April 19, 2017

**Re: Kings Point CSP No. 2 / Final Plat No. 2 Response to Initial Submission Review**  
Application Number: **DA-1609-17**  
Case Numbers: **2016-4013-00; 2016-3041-00**

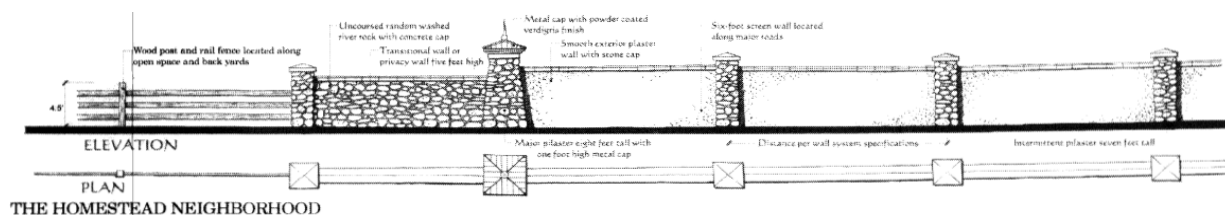
8T. Please make sure all streets are labeled on all sheets.

**Response: All streets are labeled on all sheets.**
